**MULTNOMAH COUNTY
DETENTION CENTER REMODEL
MECHANICAL PLATFORM**

INFORMATION BULLETIN

PROJECT: Multnomah County MCDC Booking
Remodel

NO.: IB-2

DOOR L131 & L132 PLAN REVISIONS

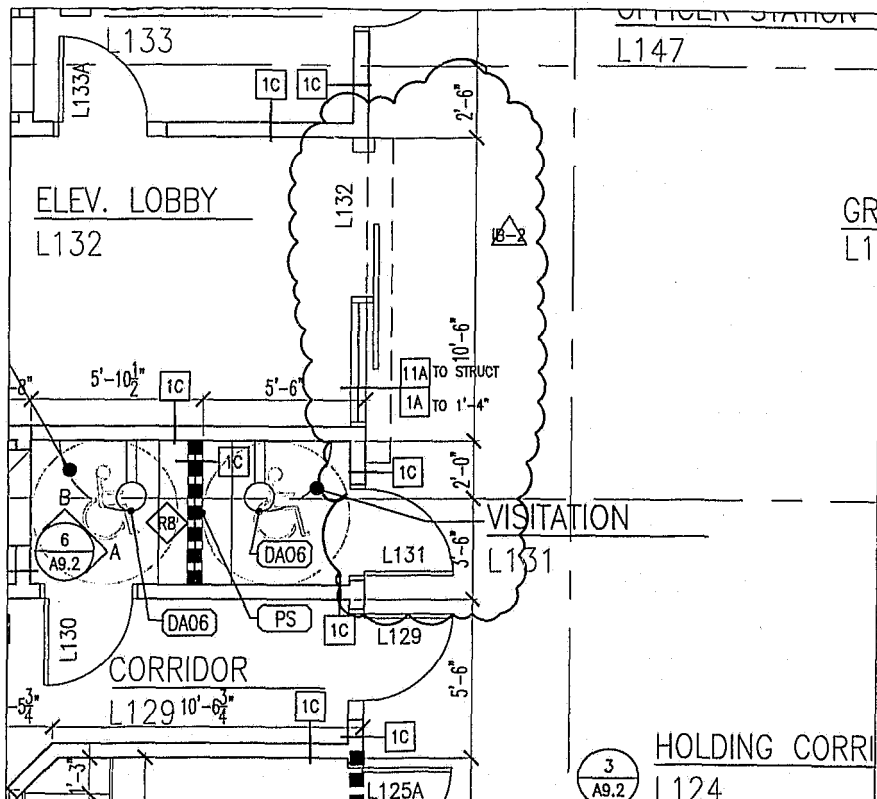
- IB-2.1 Provide: Change door swings on doors L131 and L132 as shown on drawing IB-2. Doors were approved in Habersham/Grand Openings shop drawing, items No. 30 & 31.
- Door L131 changes from LH to RH swing. Hardware stays the same.
- Door L132 changes from RH to LH with the door operator changing opening directions. Opener remains on Waiting area L124 side.

PARTIAL PLAN RECORDS L110

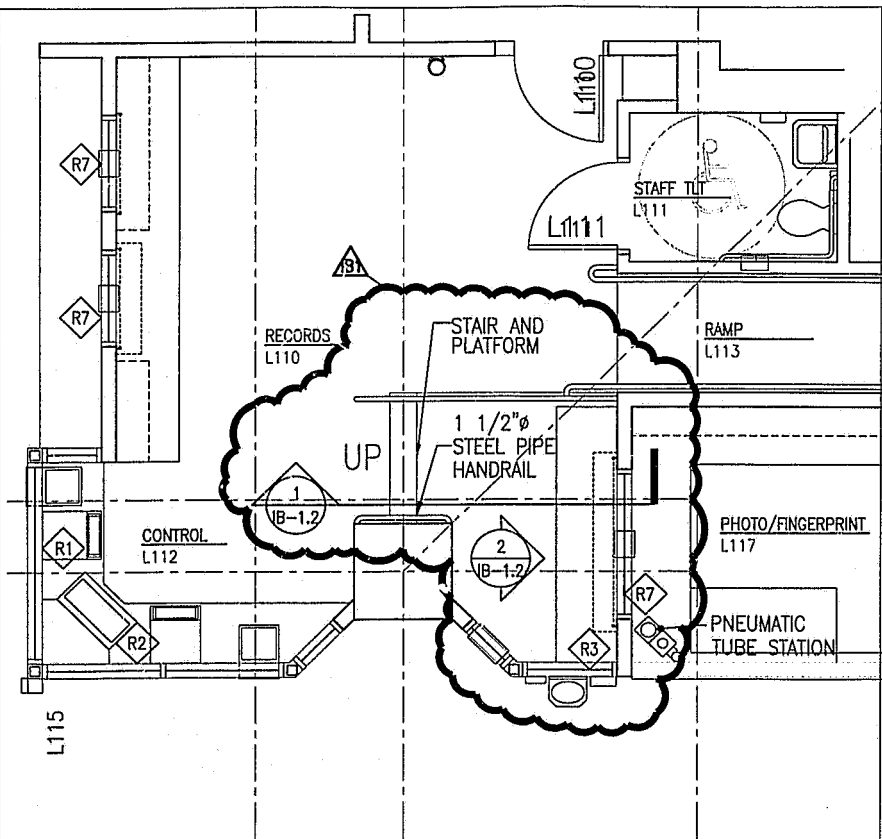
IB-1.1 Provide: Elevated wood platform, constructed from Douglas Fir, 2 by framing, 3/4" plywood flooring, with stair, skirt and toe kick. An 1 1/2" nominal diameter steel pipe handrail shall be provided at the existing concrete column and a steel pipe handrail/guardrail shall be constructed at the North side facing the Records area. Provide an extra pipe post to accept the handrail extension from the ramp at Room L113. The elevated platform and stairs shall be carpeted to match the balance of the Records area.

1 PARTIAL SECTION RECORDS L110

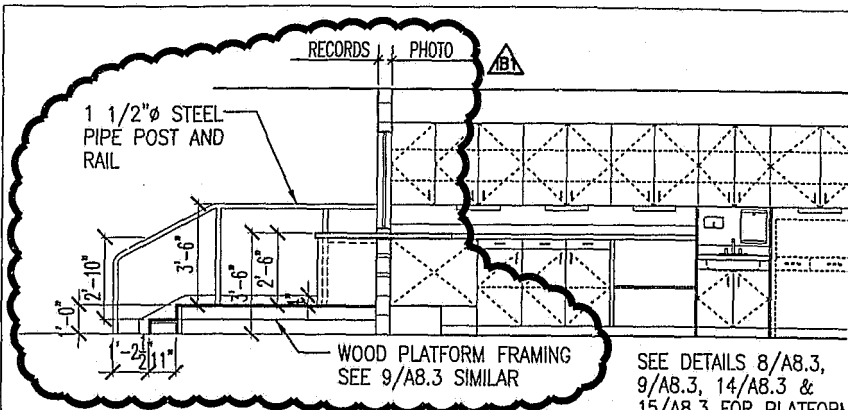
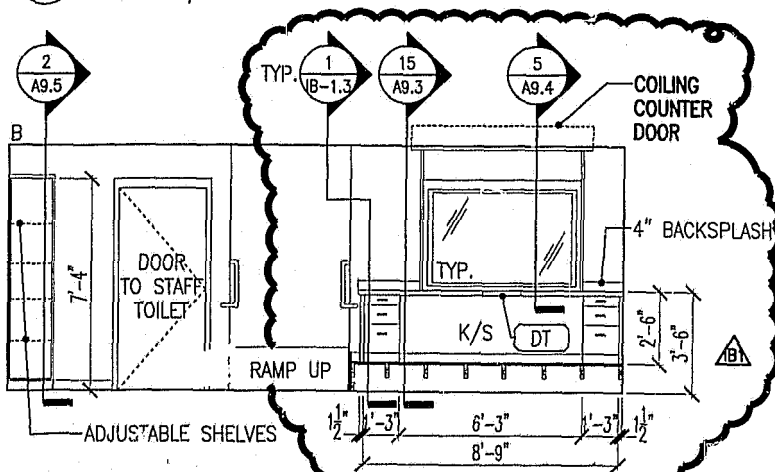
Revise: Interior elevation 4/A9.1 per 2/IB-1.2
